Wisconsin Department of Transportation

**Proposal #30: 1517-75-72, WISC 2017 345
USH 10 – USH 10/STH 441
County CB – Oneida St
Midway Interchange Mainline
USH 10
Winnebago County**

This is Addendum No. 01, which provides for the following:

Addendum No. 01
ID 1517-75-72
Added Sheet 52A
May 31, 2017

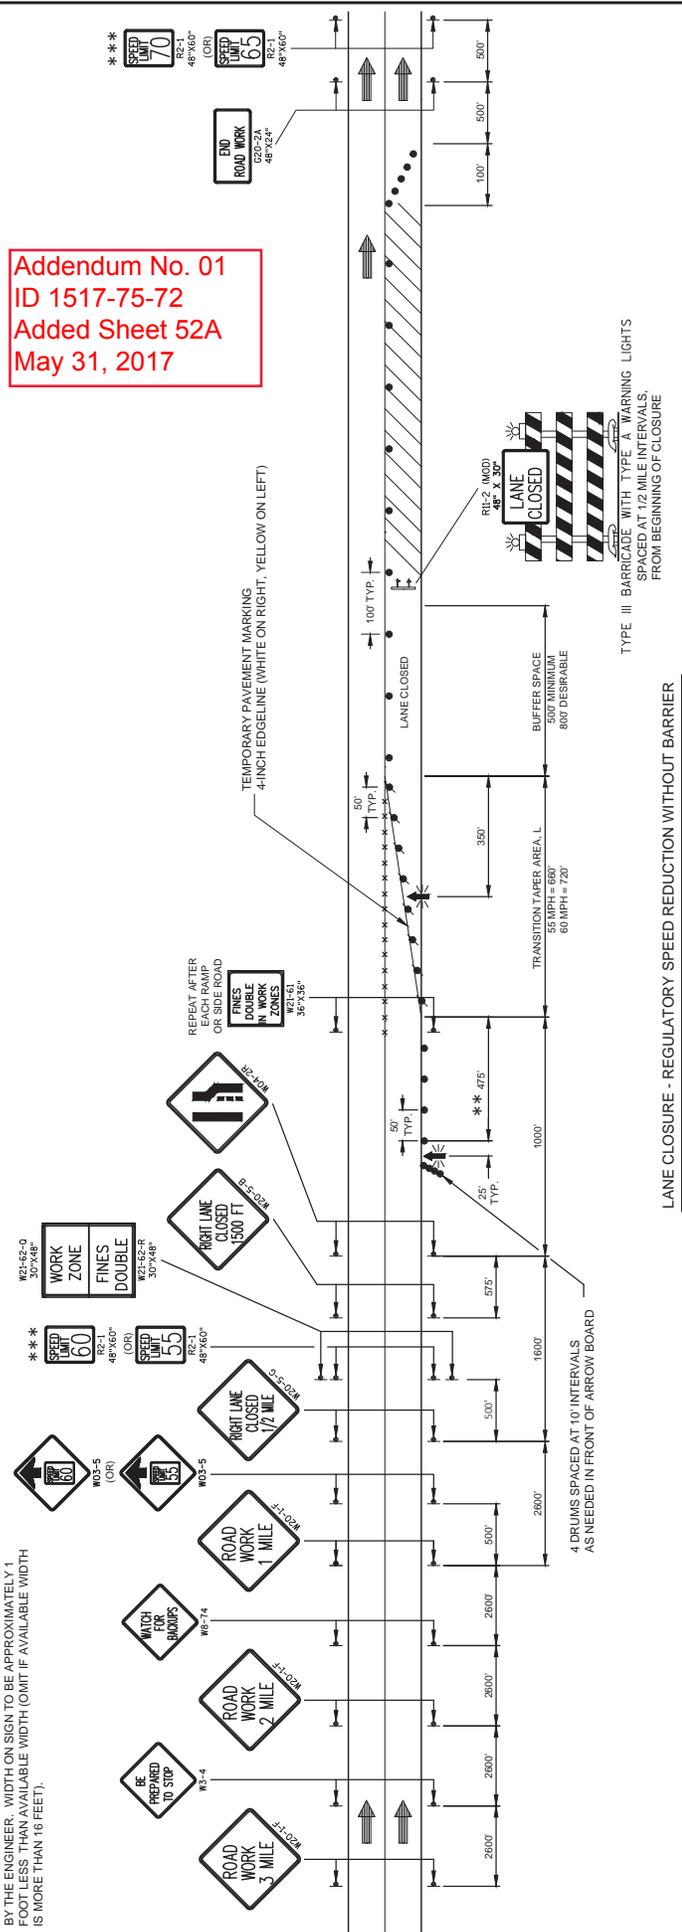
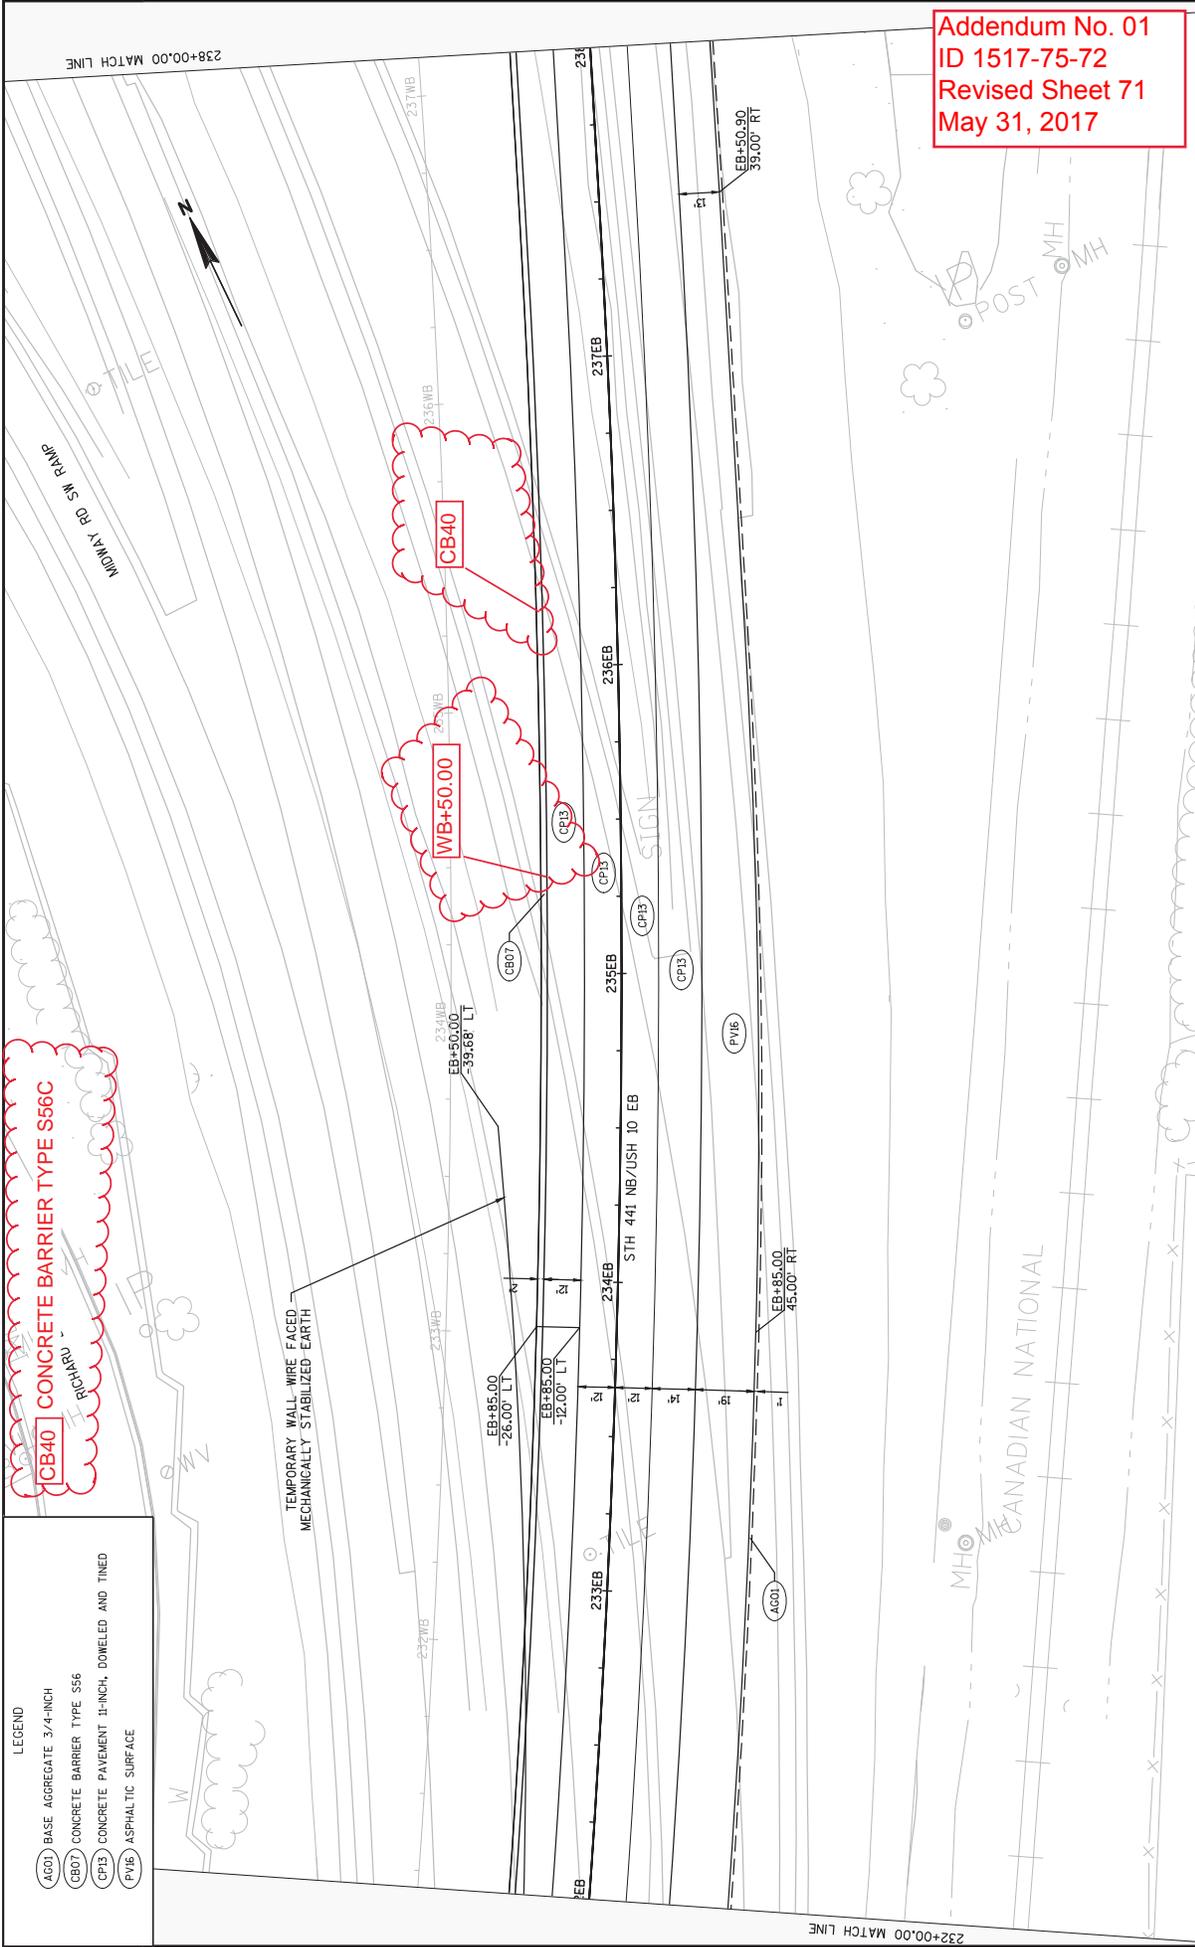
Added Plan Sheets	
Plan Sheet	Plan Sheet Title (brief description of why sheet was added)
52A	Construction Detail- Lane Closure- Regulatory Speed Reduction Without Barrier
233A – 233C	Traffic Control Detail – Racine Rd NB On-Ramp Closure
293A	Miscellaneous Quantities – Signing Type I and II

Provide proper signing see construction detail- Lane Closure- Regulatory Speed Reduction Without Barrier.

Addendum No. 01
 ID 1517-75-72
 Revised Sheet 72
 May 31, 2017

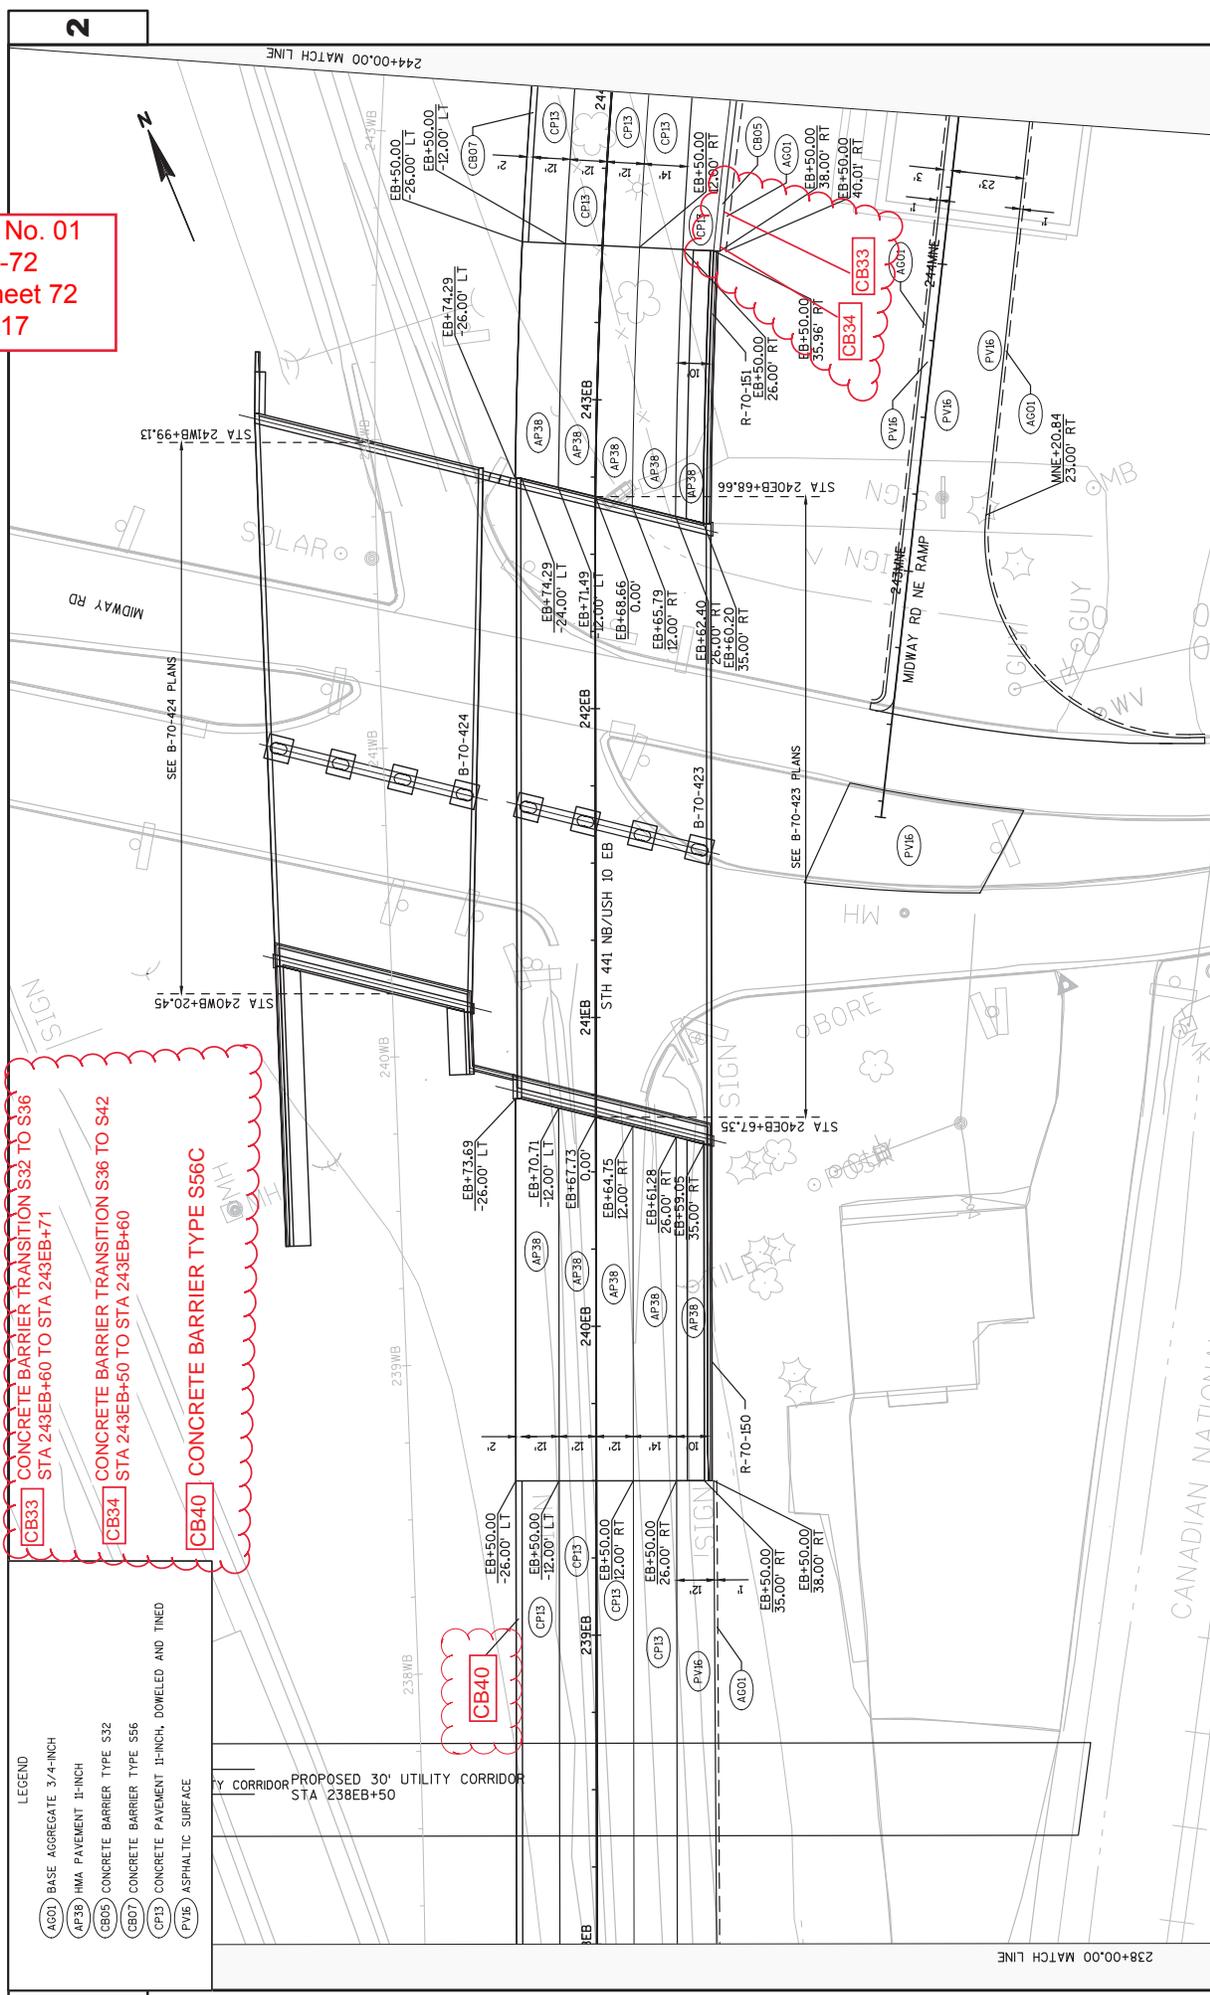
Revised Plan Sheets	
Plan Sheet	Plan Sheet Title (brief description of changes to sheet)
71	Plan Details, Added Concrete Barrier Type S56C, CB 40
72	Plan Details- Added CB33 and CB 34 locations and added Concrete Barrier Type S56C, CB 40
143	ITS General Notes- Signed PE Signature
144	ITS-Wiring Details- Notes Changed
145	ITS-USH 10/STH 441 – The notes to relocated the permanent camera has been revised

Addendum No. 01
ID 1517-75-72
Revised Sheet 181
May 31, 2017

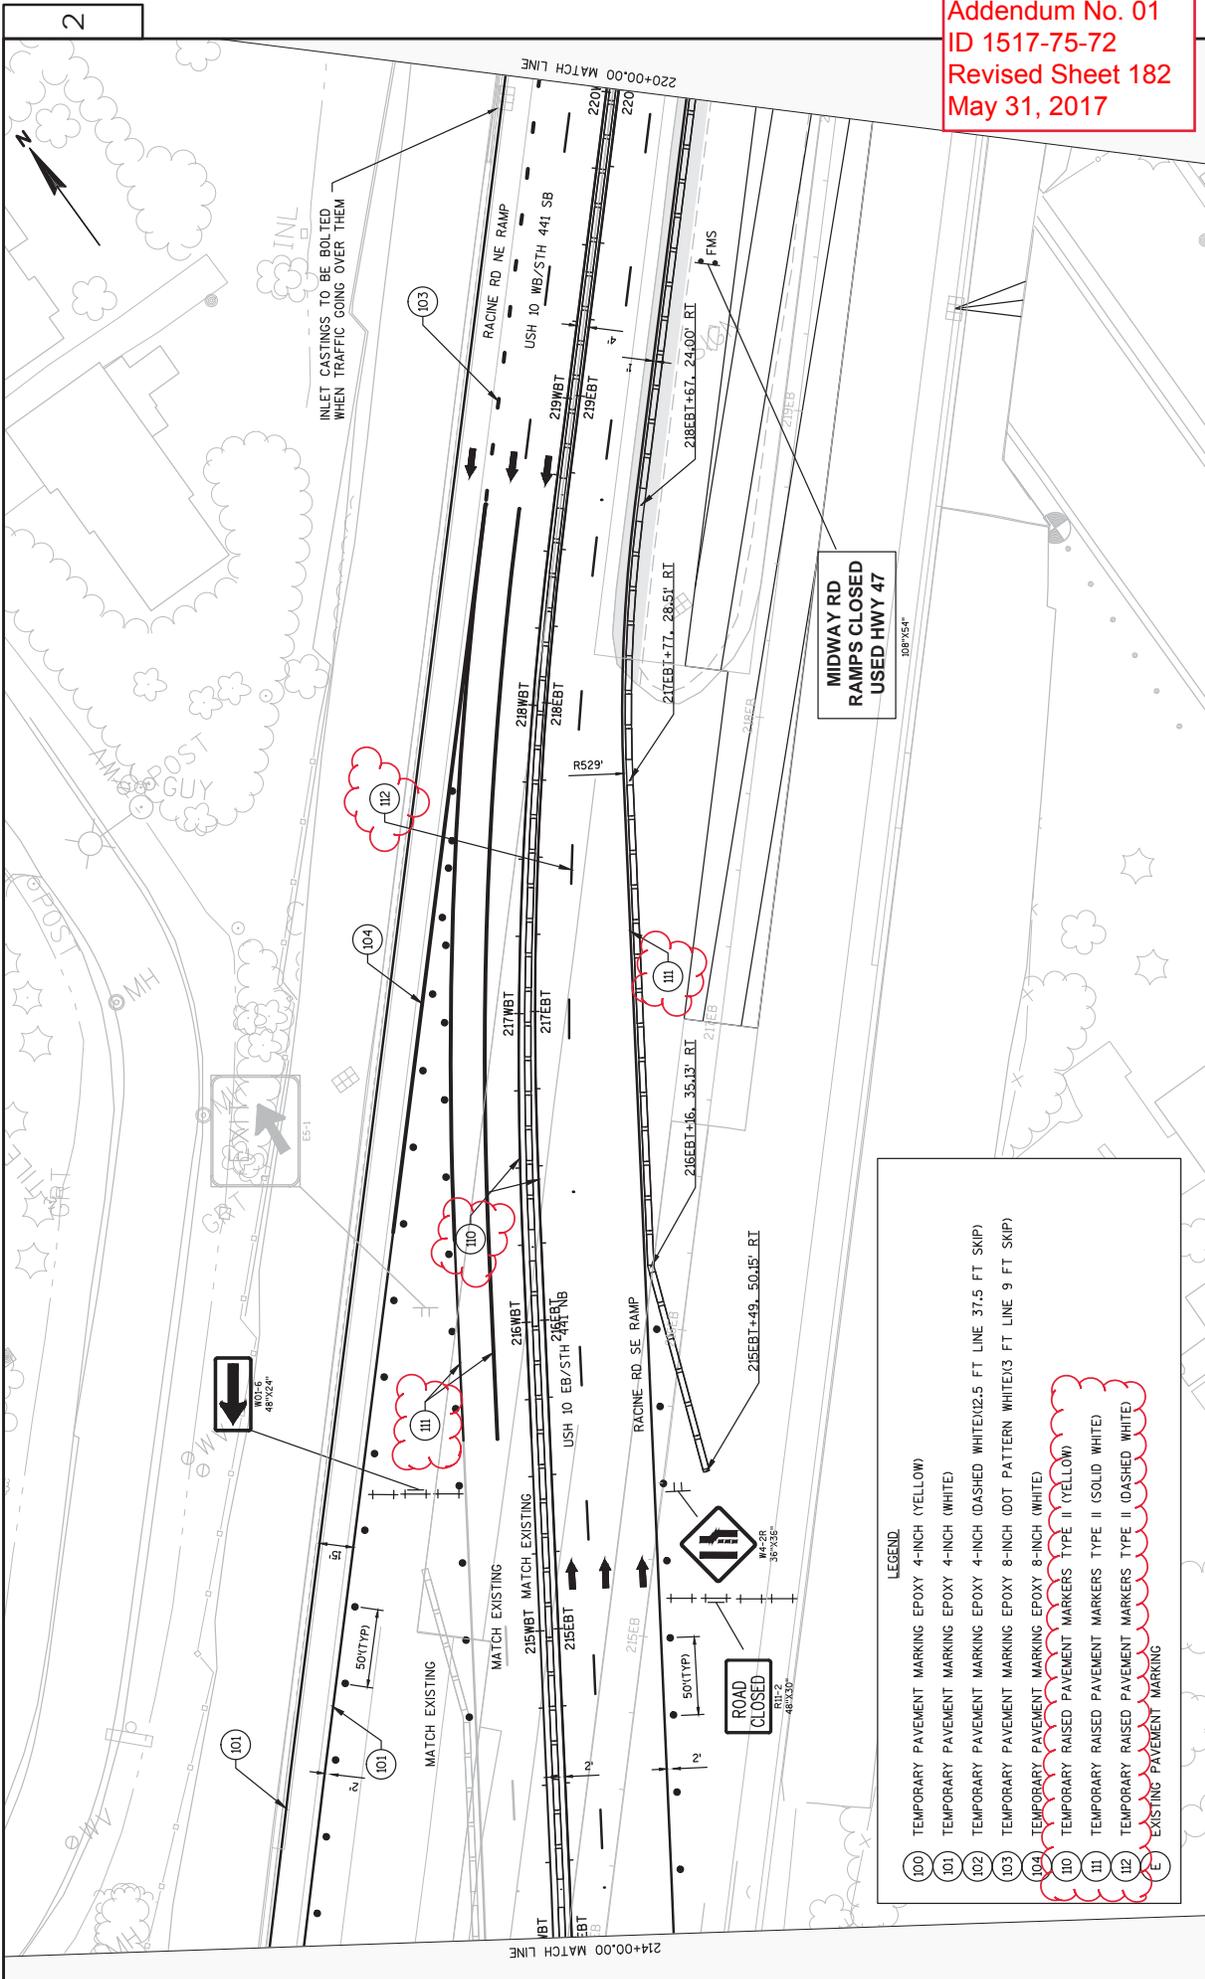
181	Traffic Control Stage 1A – Added Temp. Raised Pavement Markers
182	Traffic Control Stage 1A – Added Temp. Raised Pavement Markers
187	Traffic Control Stage 1 A- Added location for Anchored Barrier
188	Traffic Control Stage 1 A- Added location for Anchored Barrier
189	Traffic Control Stage 1 A- Added location for Anchored Barrier
190	Traffic Control Stage 1A – Added Temp. Raised Pavement Markers and location for Anchored Barrier
195	Traffic Control Stage 1A – Added Temp. Raised Pavement Markers
196	Traffic Control Stage 1A – Added Temp. Raised Pavement Markers
199	Traffic Control Stage 1A – Added Temp. Raised Pavement Markers
206	Traffic Control Stage 1A – Added location for Anchored Barrier
274	Miscellaneous Quantities – Stage 1 B Earthwork Station has changed
275	Miscellaneous Quantities – 311.0110 Breaker Run quantities revised
276	Miscellaneous Quantities- 455.0605 Tack Coat quantities revised and 601.0411 title in MQ's only changed.
